Service Manual

SE-VC1180

- Notes:**
- This service manual is provided to indicate the main differences between the original model No. SE-CA1080 (E) and the subsequent model No. SE-VC1180 (E, EB, EG).
 - Refer to the Connections, Quick reference of remote control operation and Preparing of the remote control of Service manual for Model No. SL-VC1180 (E), Order No. AD9506160C2.

CHANGES

A OPERATION CIRCUIT

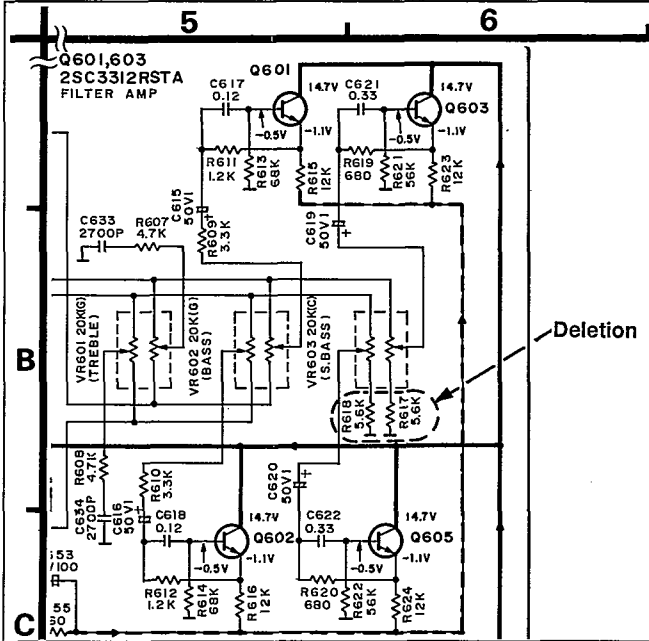
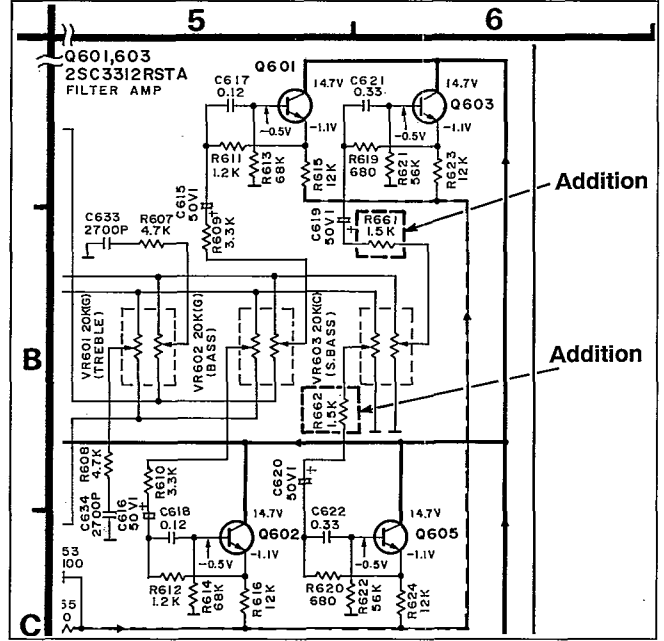
Note: Those parts have added.

A OPERATION P.C.B. (REP1924B-S)

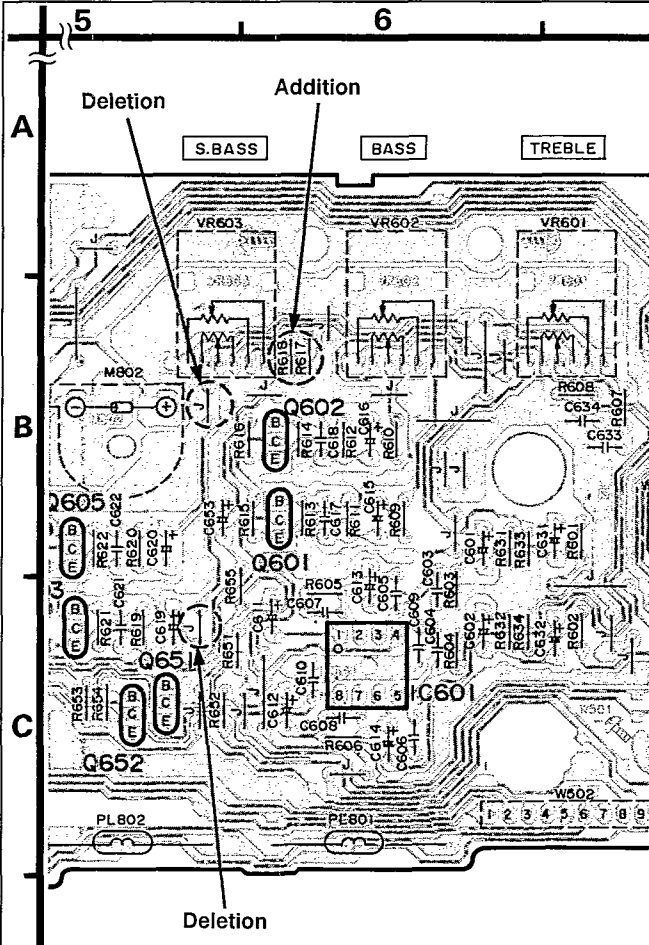
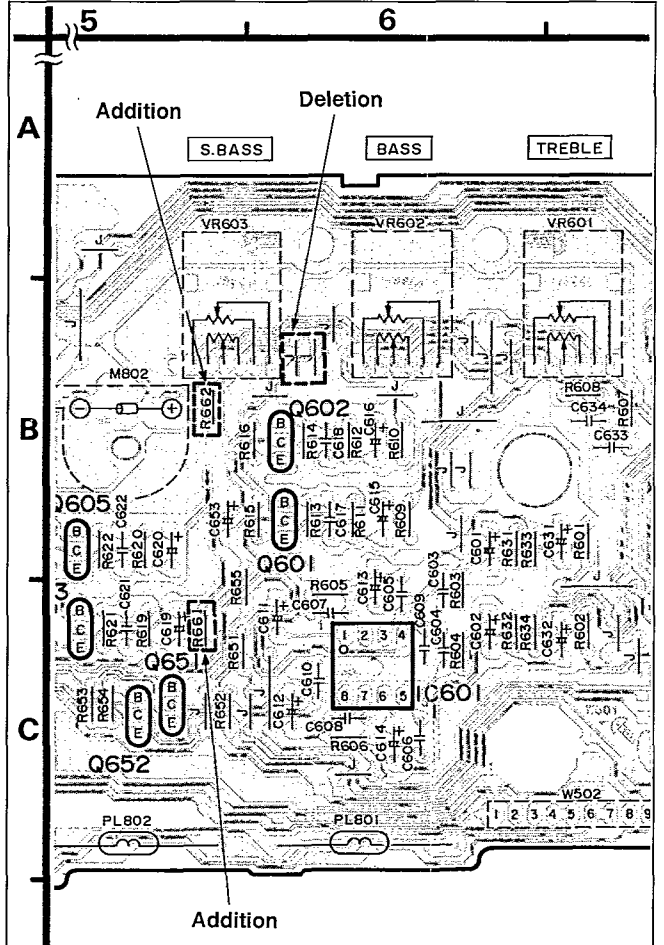
Note: Those parts have added.

CABINET PARTS LOCATION (SE-CA1080 Service Manual of page 16.)

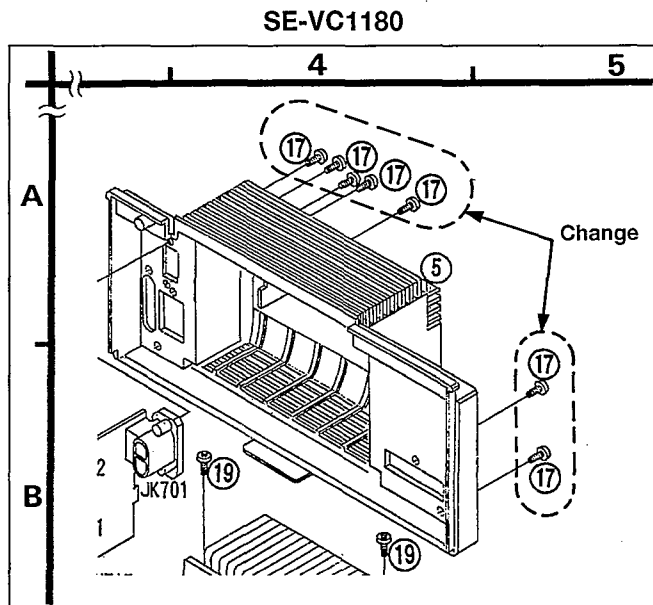
Note: Those parts have changed.
